SSD-32275057

Redfern Mixed Use Co-living Housing Objection

29th November 2022

Figure 24: Photograph of the existing lightwell to No 6-8 Woodburn Street to the southern boundary shared with No. 9 Woodburn Street.

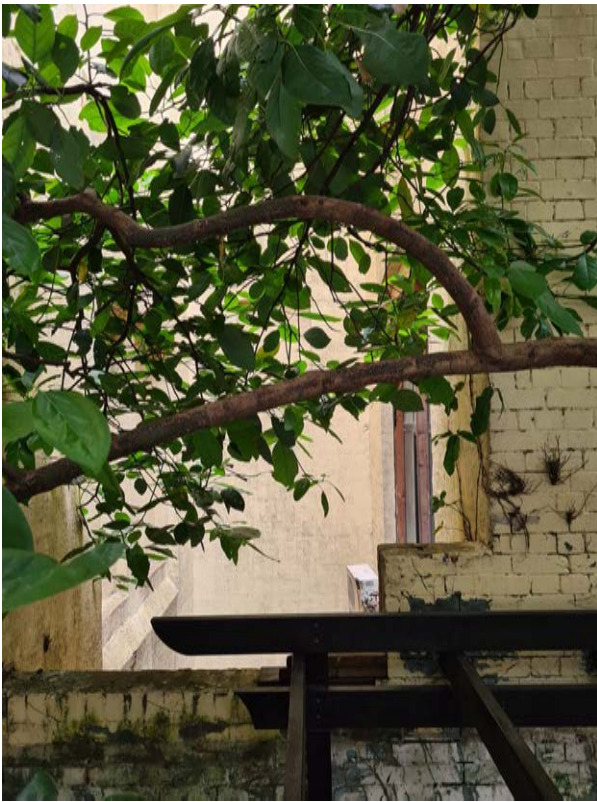
Figure 21: Photograph of the existing southern wall along the boundary between No. 6-8 Woodburn Street and No. 9 Woodburn Street. I request that this wall be retained to the boundary in this location and incorporated into the new construction of the proposed ground floor commercial space. If it is not possible to retain this wall, I request that the new wall be the same quality face brick as used elsewhere in the development.

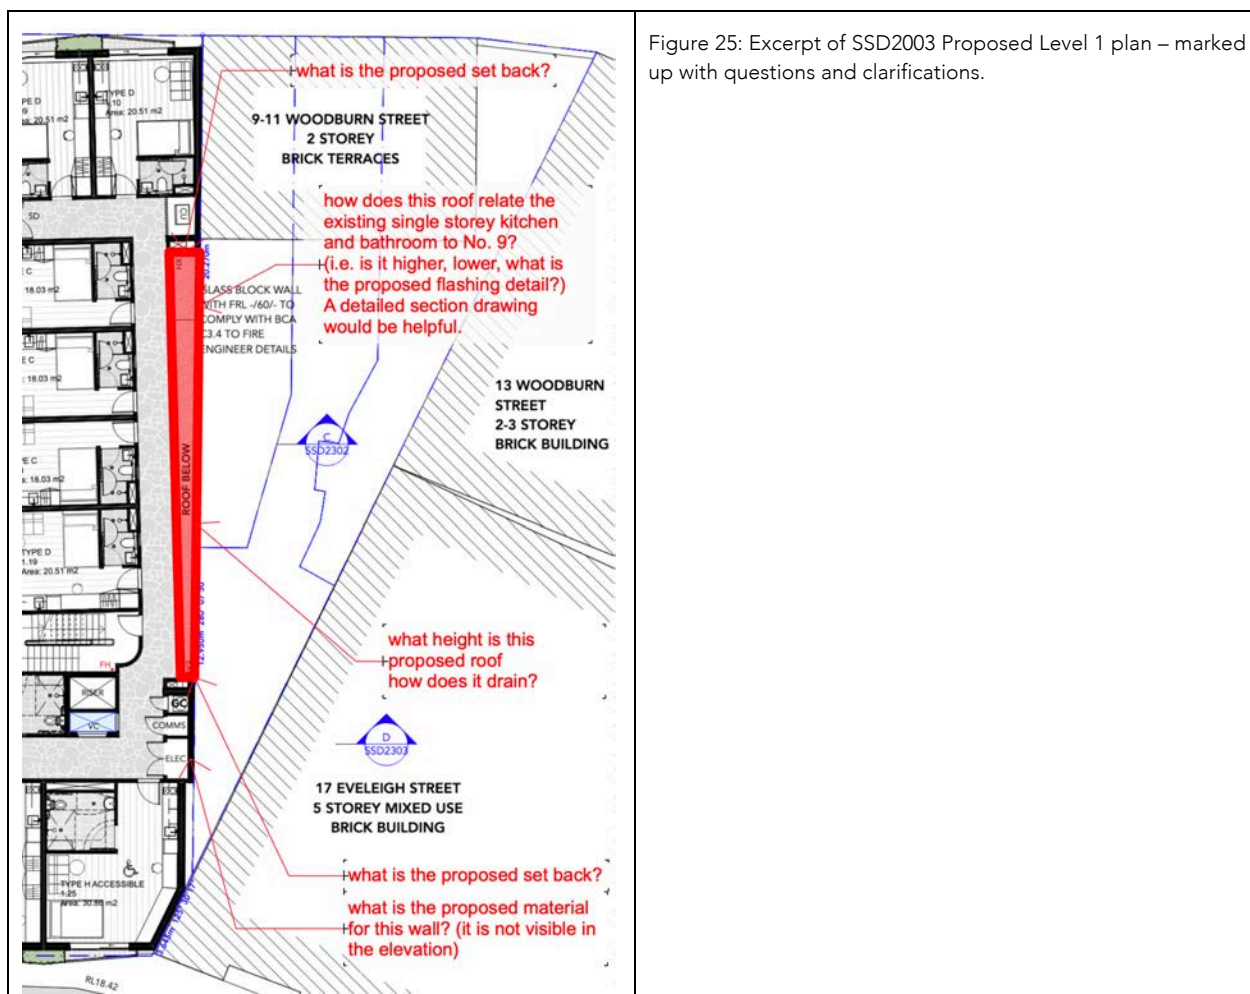
I would also like to know what height the proposed roof is (section shaded red in the excerpt below), how this roof drains, and how this roof will relate to the single storey kitchen and bathroom of No. 9. It would be very helpful if a detailed section could be provided as part of the assessment in order to show how these items are proposed to be resolved. My preference is for the new wall to be slightly higher than my kitchen roof so that I can appropriately flash over the new wall. My desired outcome is for a detail that is as waterproof for both properties as possible.

I would also like to know what the proposed materiality is for the wall adjacent to No. 10 Woodburn Street as this is not shown on the elevations.

Figure 26: It is unclear from the proposed plans and elevations what height the proposed ground floor wall to the boundary is proposed to be. I would request that the height of the wall be sufficient to finish above my existing single storey kitchen and bathroom roof (as pictured above) in order to avoid a potential water ingress and maintenance issue of having a weird small section of lower roof between the two buildings along the boundary.

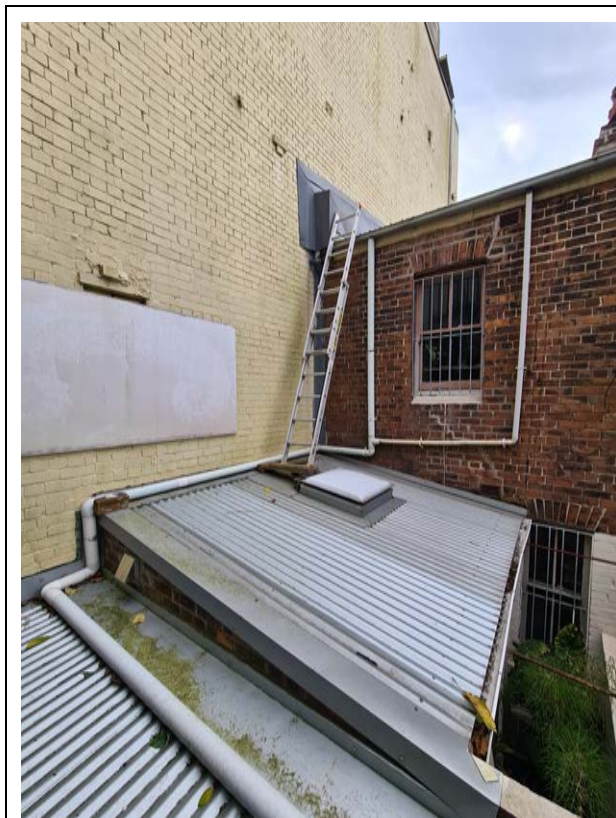
Figure 27: It is unclear from the proposed plans and elevations what height the proposed ground floor wall to the boundary is proposed to be. I would request that the height of the wall be sufficient to finish above my existing single storey kitchen and bathroom roof in order to avoid a potential water ingress and maintenance issue of having a weird small section of lower roof between the two buildings along the boundary.

Figure 28: Excerpt of SSD2007 Proposed Level 5 plan – the area circled in red is the area of small garden and seating that I am concerned about.

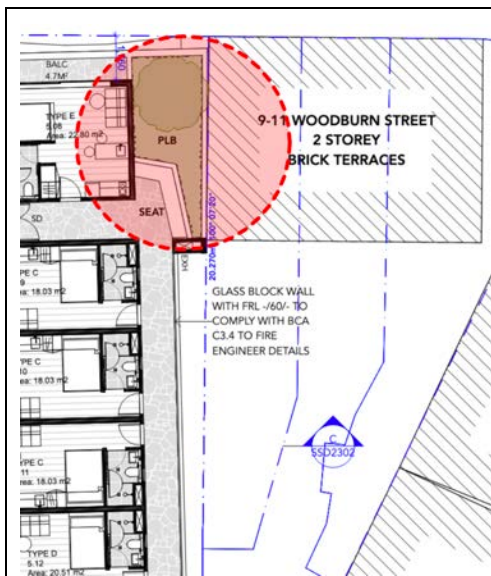
I am concerned about the small section of garden and seating proposed to the south eastern corner of the development adjacent to the front of No. 9 Woodburn Street. I am in favour of the proposed garden, however I am concerned about the potential for occupants to throw objects over the roof and on to my property. Occupants of No. 6-8 Woodburn Street have previously thrown rubbish and various items off the rooftop into my rear courtyard. I have no objection to recreational roof top space provided that the amenity of surrounding properties is protected from noise, overlooking and the potential to throw rubbish or objects into private open space.

Figure 30: Photo showing the existing parapet height on No. 17 Eveleigh Street. The proposed parapet should match the existing parapet at No. 17 Eveleigh Street.

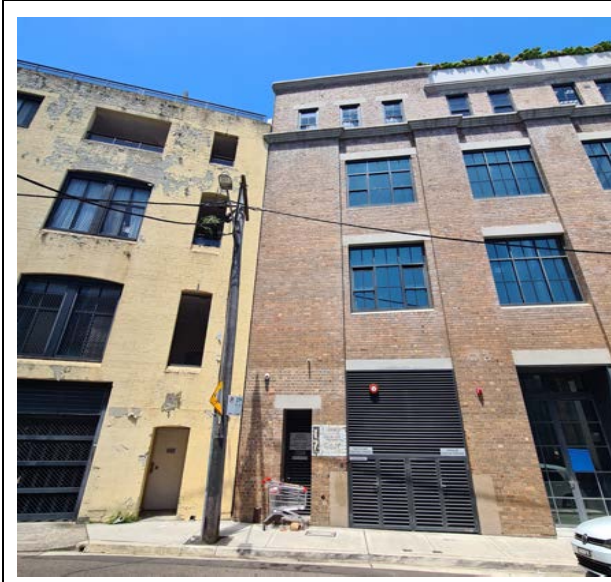
This elevation shows that existing brick parapet height of No. 17 Eveleigh Street is RL 35.800, the proposed street frontage height to Eveleigh Street should match this height at the southern end in order to form a coherent streetscape. The top roof of No. 17 Eveleigh Street is RL 39.170, and the bulk of the proposed Level 6 has an RL of 43.600 – that is 4,430mm higher than that approved on the site adjacent (which is an adaptive re-use project containing three original warehouse floor to ceiling heights which are considerably taller than modern residential floor to ceiling heights). There is absolutely no reason that a successful development cannot be proposed on this site that complies with the height limit of 5 storeys. The proposed 5th and 6th storey is excessive and unnecessary.

Figure 29: Excerpt of SSD2400 West Elevation (Eveleigh Street) – the proposed street parapet should match the existing parapet height at No. 17 Eveleigh Street.

Figure 32: Excerpt of SSD2401 East Elevation (Woodburn Street) showing different options for a transitional scale that would be more appropriate to the adjacent height, bulk and scale, creating a more harmonious streetscape and would largely remove the amenity issues.

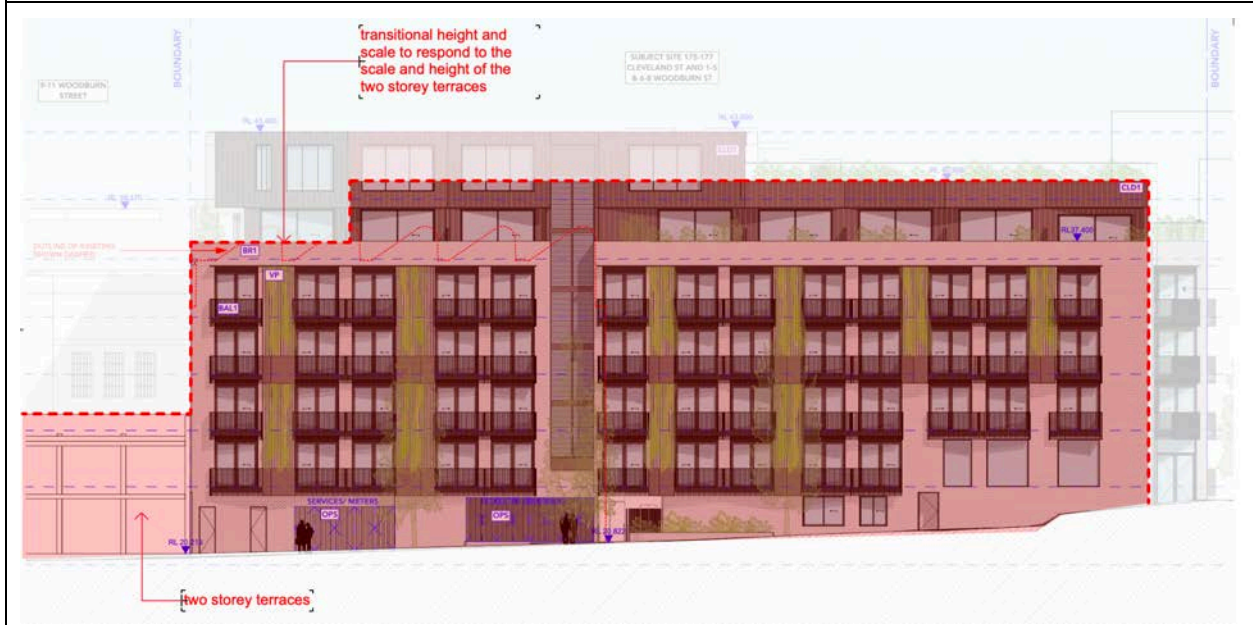
This elevation shows the full impact of the proposed height, bulk and scale on the three two-storey terraces located to the south of the proposed development. The outline of the existing shows that should the development proceed with a compliant 5 storey height that additional impacts of the development on the three terrace houses would be negligible. The proposed Levels 5 and 6 add a height of 6 metres above the proposed 5 storey street front parapet height of RL 37.400. This 6 metre non-compliance affects the amenity of No. 9, 10 and 11 Woodburn Street in the following ways:

- It is common practice for new buildings in existing and historic contexts to architecturally use a setback with a transitional scale more appropriate to the adjacent height, bulk and scale of existing and adjacent buildings before stepping up to a higher scale. A transitional section directly adjacent to the terraces would allow create a more harmonious streetscape and largely remove the amenity issues.

Figure 31: Excerpt of SSD2401 East Elevation (Woodburn Street) showing different options for a transitional scale that would be more appropriate to the adjacent height, bulk and scale, creating a more harmonious streetscape and would largely remove the amenity issues.

Figure 33: Excerpt of SSD 2403 South Elevation marked up with questions and clarifications.

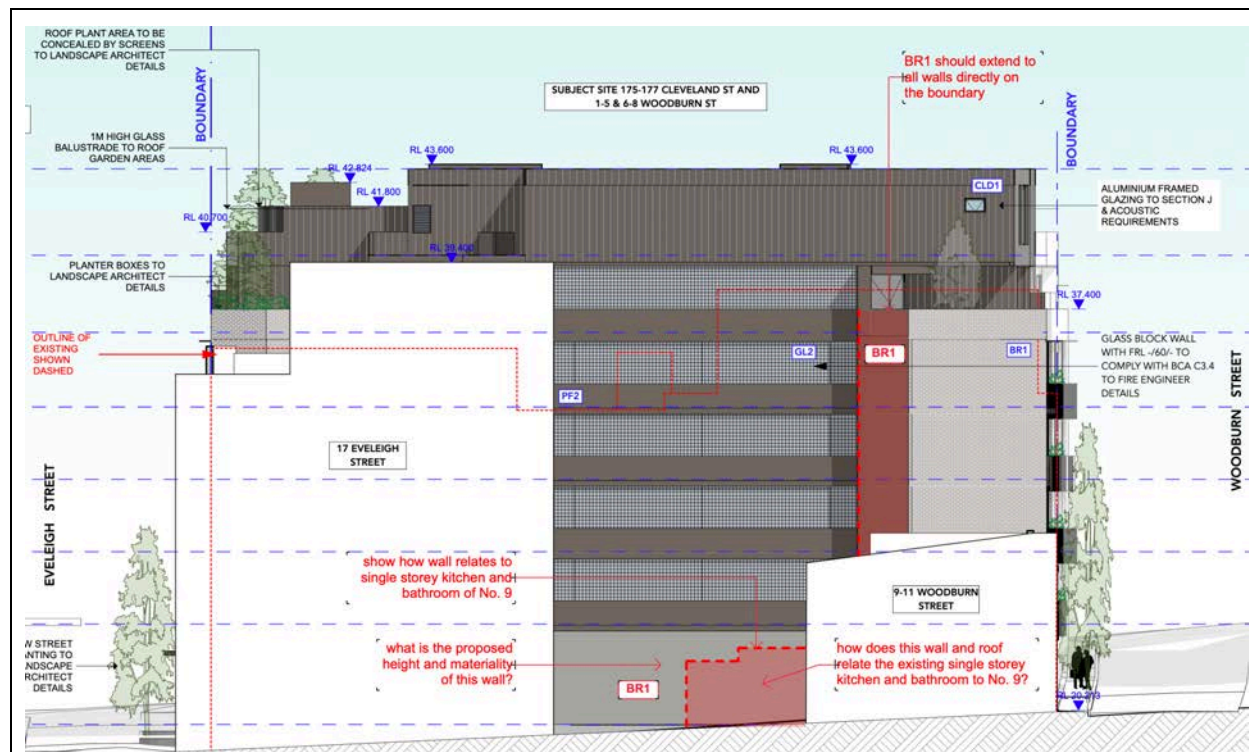
It is unclear from the drawings what the proposed height and material is for the wall adjacent to the boundary with No. 9 and No. 10 Woodburn Street to the new commercial/retail space.

The drawing shows a grey rectangle and is not labelled with the proposed materiality.

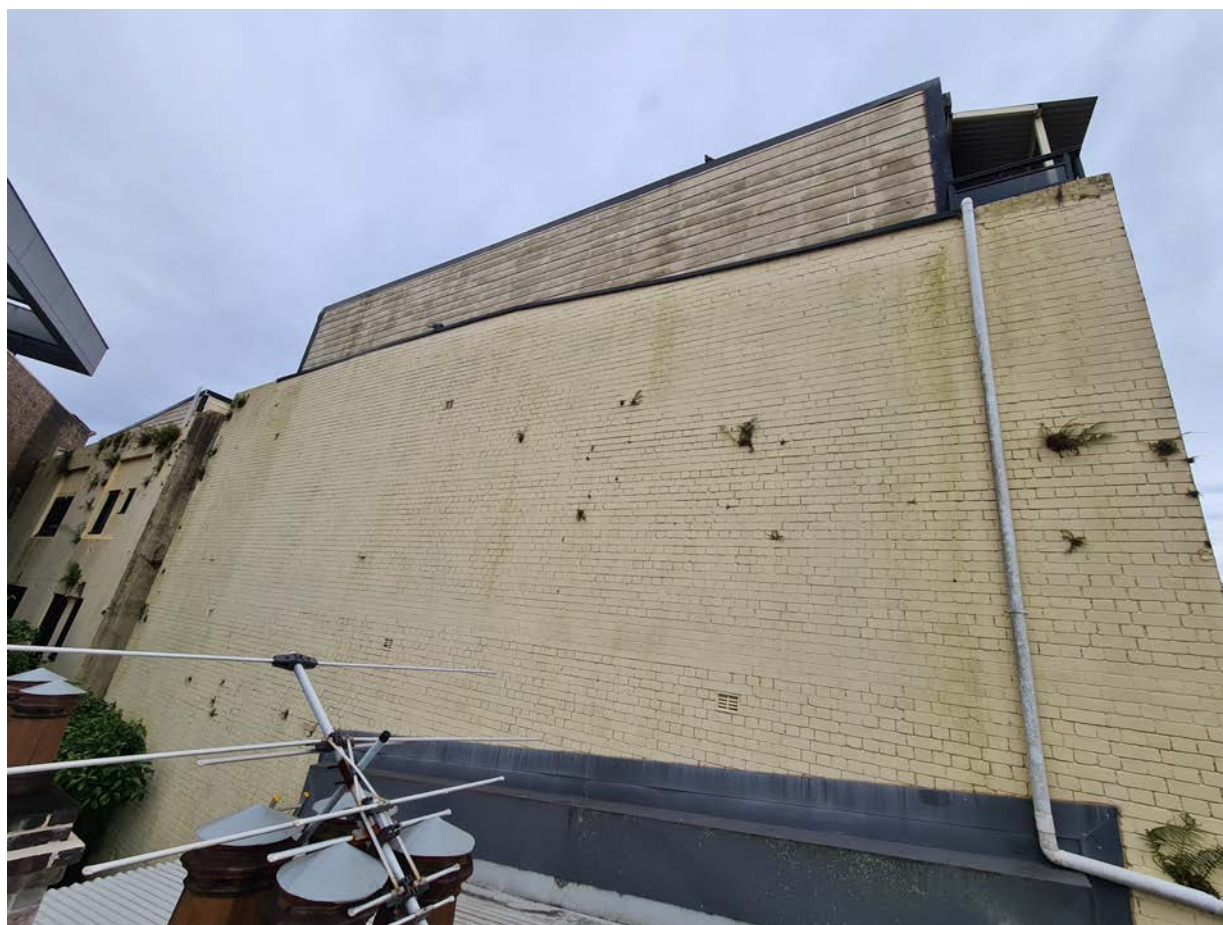
Figure 34: Photo showing the extent of the already imposing brick wall to the southern boundary of No. 6-8 Woodburn Street. I object to the proposed paint finish and colour to this wall due to concerns about quality of the building materials and the likely hood that finishes to this façade will not receive maintenance over time (as is evidenced in the existing situation where maintenance to this façade is not carried out because of difficulties with access). I request that the material used for the walls of the façade match the rest of the development, being a high-quality face brick.

Should the planning department assess the paint finish as being acceptable, I would request that a lighter colour (not white) that the 'dark bronze' proposed be used so as to a maximise reflected, ambient light into the already dark and overshadowed private open spaces of No. 9, 10 and 11 Woodburn Street.
